MONTGOMERY COUNTY HISTORIC PRESERVATION COMMISSION
STAFF REPORT

Address:	6 Primrose Street, Chevy Chase	Meeting Date:	4/12/2023
Resource:	Contributing Resource Chevy Chase Village Historic District	Report Date:	4/5/2023
Applicant:	Caitlin Steed (Marci Bonner, Agent)	Public Notice:	3/29/2023
Review:	HAWP	Tax Credit:	N/A
Permit Number:	1023924	Staff:	Dan Bruechert
PROPOSAL:	Tree Removal, Hardscape Alteration, and Fence Installation

Figure 4: Staff recommends the HAWP approval not include the section of fence outlined in red.

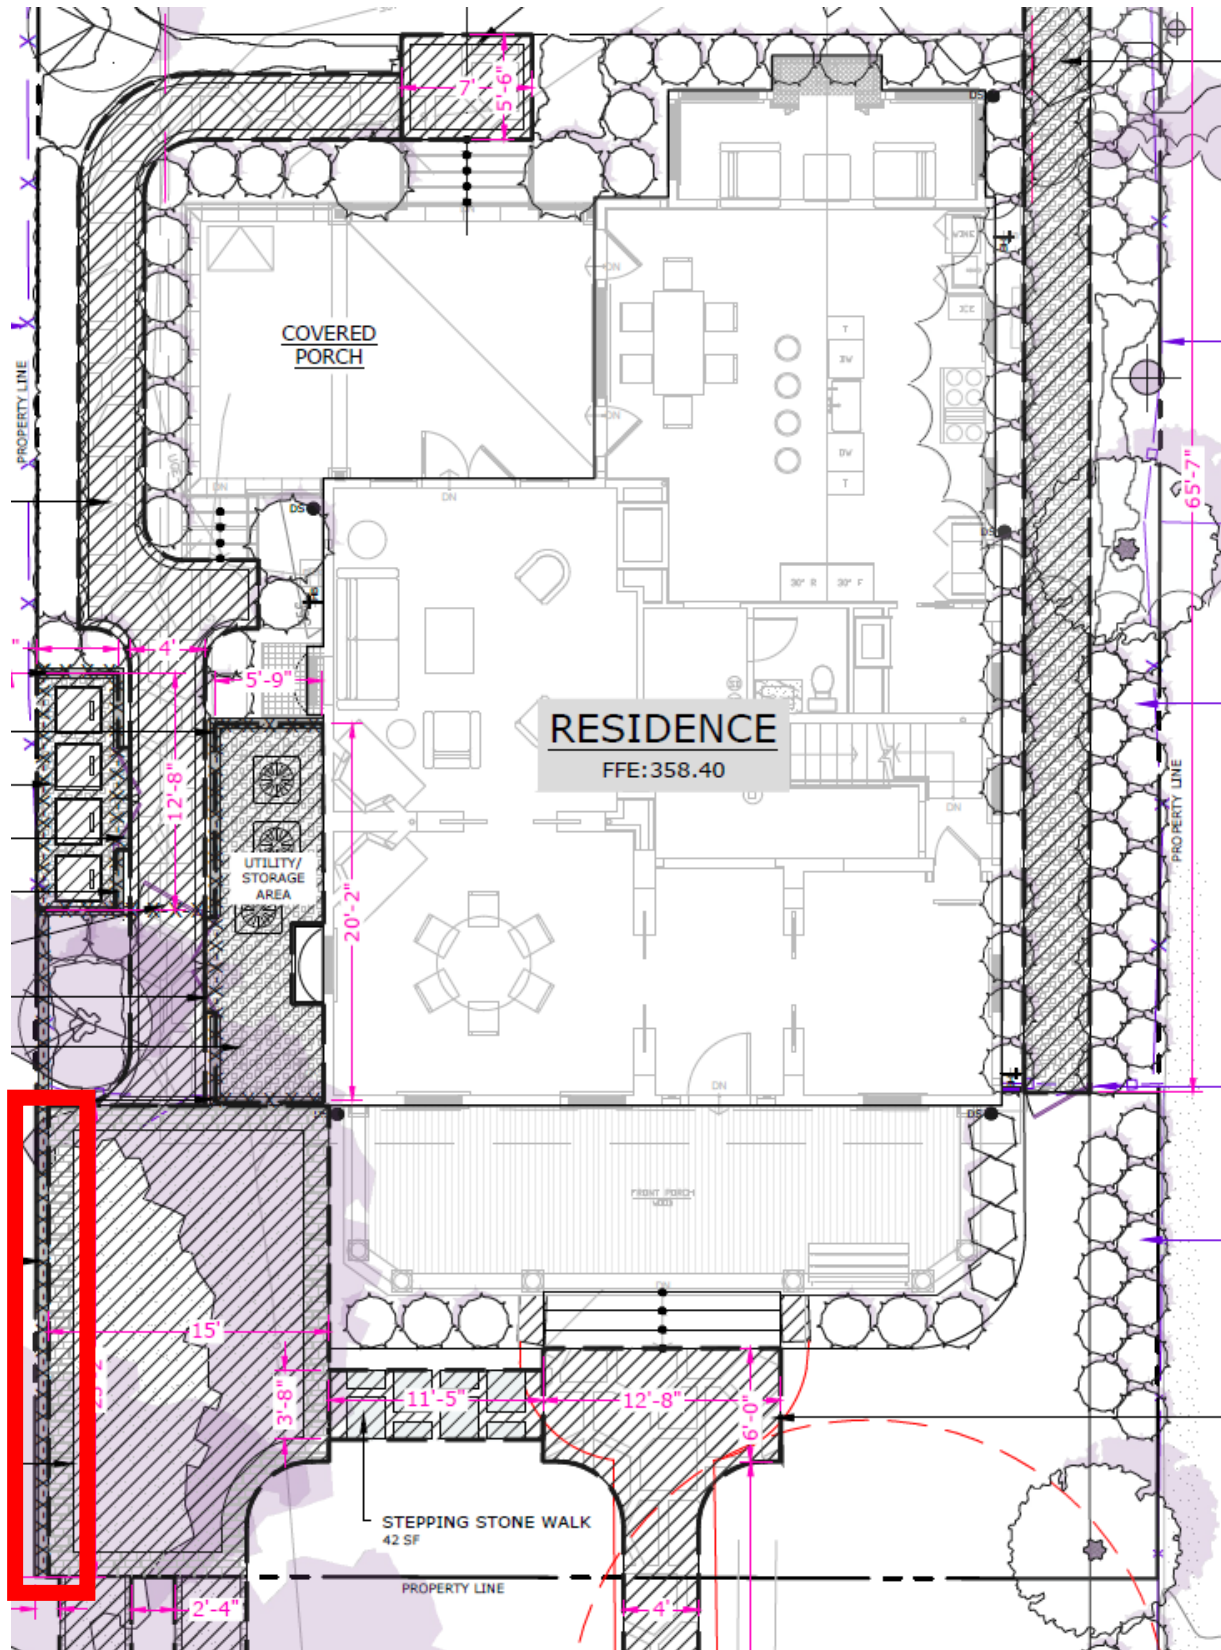
In addition to the fencing around the storage/utility area, discussed above, the applicant proposes additional fencing to the left of the house. Immediately to the left of the house, the applicant proposes to construct a 4' (four foot) tall solid board enclosure around the existing HVAC units and a basement window well with a gate. Adjacent to this enclosure, the applicant proposes to construct an enclosure for trash and recycling. The fence surrounding this enclosure matches the design, materials, and height of the other enclosures proposed. Finally, the applicant proposes to remove a section of existing 6' (six foot) tall solid board fencing and install 48' 3" (forty-eight feet, three inches) of 6' (six foot) tall solid board fencing. This fence comes 25' 2" (twenty-five feet, two inches) forward of the house front wall plane.

Staff finds the proposed screening fences and gates are appropriate heights and materials for the house and recommends the HPC approve them. However, Staff does not find the full length of the proposed 6' (six-foot) tall fence to be appropriate. The general requirement for fences in the Chevy Chase Village Historic District in front of the rear wall plane is that they need to be no taller than 48" (forty-eight inches), constructed out of traditional materials, and have an open (i.e. picket) design. This requirement helps to preserve the Village's open, park-like setting, and objective identified in the 'Lot Coverage' guideline. The existing 6' (six foot) tall fence was approved by the HPC, in part, to enclose the rear yard and comply with the code requirements for the since-removed swimming pool. Replacing the fencing in its current location is an in-kind replacement that does not require a HAWP. Staff finds removing and replacing the existing fence appropriate. Staff also finds that the fencing proposed in front of the house front wall plane (see below) would be detrimental to the district's open park-like setting and recommends the HPC include a condition to the HAWP approval that this section of the fence not be approved.

1. The proposed driveway apron material shall match the approved driveway. Final plans showing this condition has been satisfied shall be submitted to Staff for review and approval before releasing the final approval documents.
2. This HAWP approval does not include the installation of a generator on the property.
3. The replacement fence along the east property boundary may not extend forward of the front wall plane. A revised site plan showing this condition has been satisfied shall be submitted to Staff for review and approval before releasing the approval documents. Any new fencing forward of the front wall plane will require either a revised HAWP or a new HAWP application;

HAWP SITE PLAN

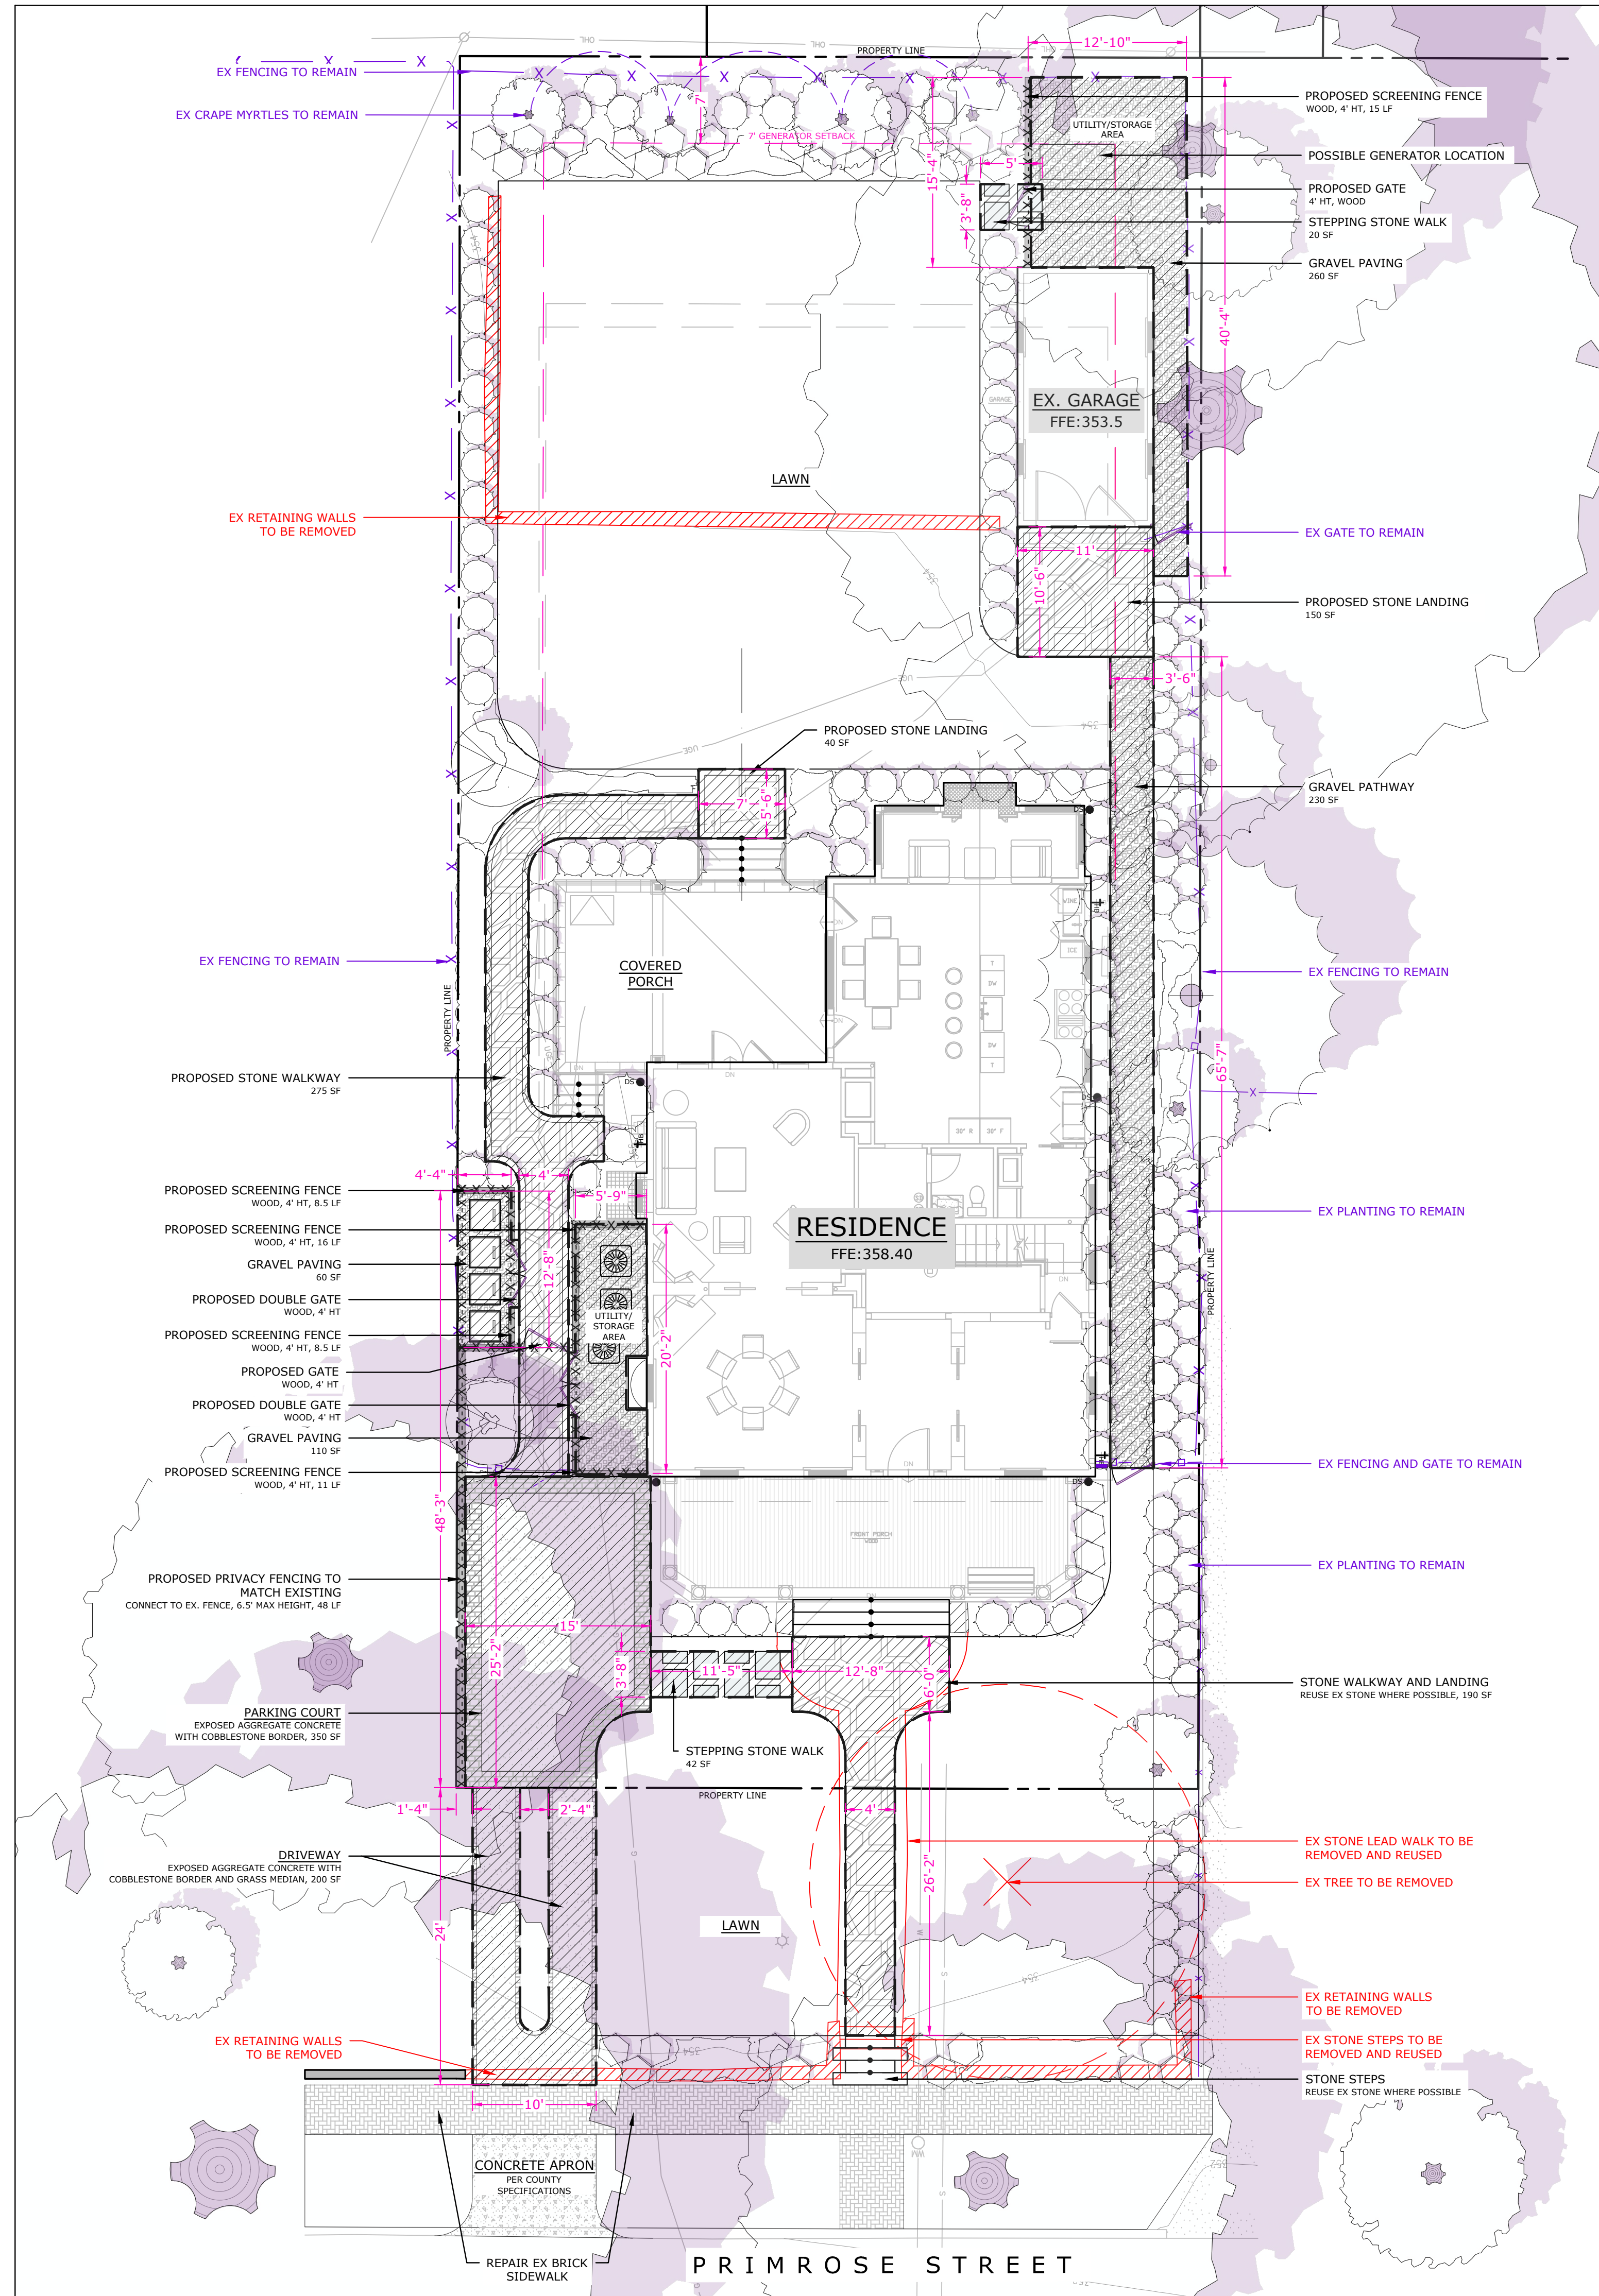
In the front yard of the subject property, there is a 10" (ten-inch) d.b.h. cherry tree (the site plan mislabeled the tree as a Wisteria). The applicant proposes to remove this tree.

In 2004, the driveway and curb cut on the right side of the property were removed.² To provide off-street parking, the applicant proposes to install a curb cut, ribbon driveway, with a 'parking court' to the left of the house. Details for the driveway apron were not included in the application, however, both the driveway ribbons and parking court will be constructed using an exposed aggregate concrete with a cobblestone border. Staff finds the proposed materials provide the desired texture to blend into the surrounding streetscape and recommends the HPC approve the new driveway. Staff recommends the HPC add a condition to this approval that the apron material matches the exposed aggregate driveway.

Behind the garage, the applicant proposes to install a "utility/storage area" measuring 12' 10" × 15' 4" (twelve feet, ten inches by fifteen feet, four inches). The proposed area will be covered in gravel with a 4' (four-foot tall) wood solid board fence. The drawings note a location for a possible generator in the enclosure. The proposed area is located behind both the house and garage and will not be visible from the right of way. Staff finds the proposed fence material and design are compatible with the character of the site and surrounding district. Staff recommends the HPC approve the proposed enclosure, but that the approval does not extend to include installing a generator in this location. If the applicant wishes to install a generator, this work requires a separate HAWP at a future date.

1. The proposed driveway apron material shall match the approved driveway. Final plans showing this condition has been satisfied shall be submitted to Staff for review and approval before releasing the final approval documents.
2. This HAWP approval does not include the installation of a generator on the property.
3. The replacement fence along the east property boundary may not extend forward of the front wall plane. A revised site plan showing this condition has been satisfied shall be submitted to Staff for review and approval before releasing the approval documents. Any new fencing forward of the front wall plane will require either a revised HAWP or a new HAWP application.
